SI B11 09 16
Engine

N63, N63TU, S63 and S63TU Engines: Oil Leak from the Rear of the Engine and Transmission Bell Housing

This Service Information bulletin replaces SI B11 09 16 dated May 2016

P/N 11 14 2 246 298 Updated End Cover, Rear Kit overview.

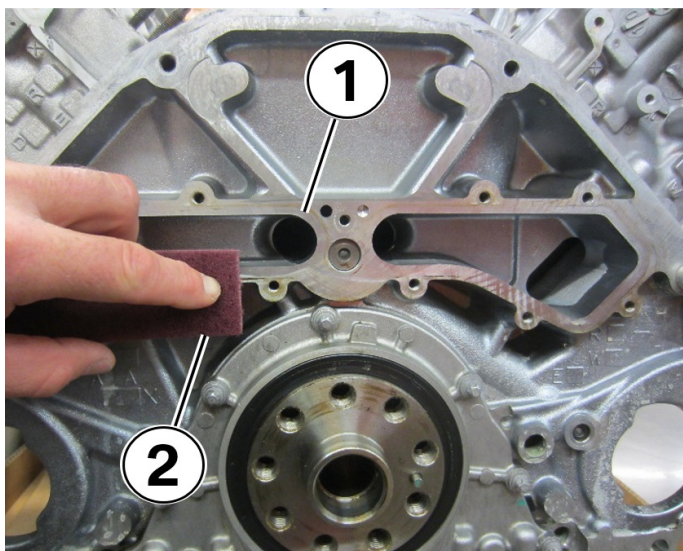
Billet aluminum housing (1)

Integrated Viton seal (2)

Additional sealed surfaced (3) to encapsulate the leaking engine oil galley plug.

17. Replace the crankshaft rear seal and seal housing (1).

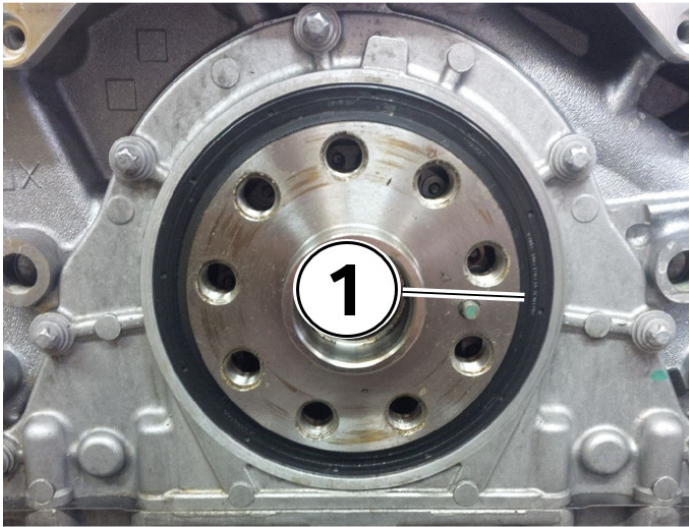
Always enter the vin number into ETK to receive the proper part number. **UPDATE!**

Refer to Repair Instruction 11 41 151 Replacing crankshaft radial seal on transmission side.
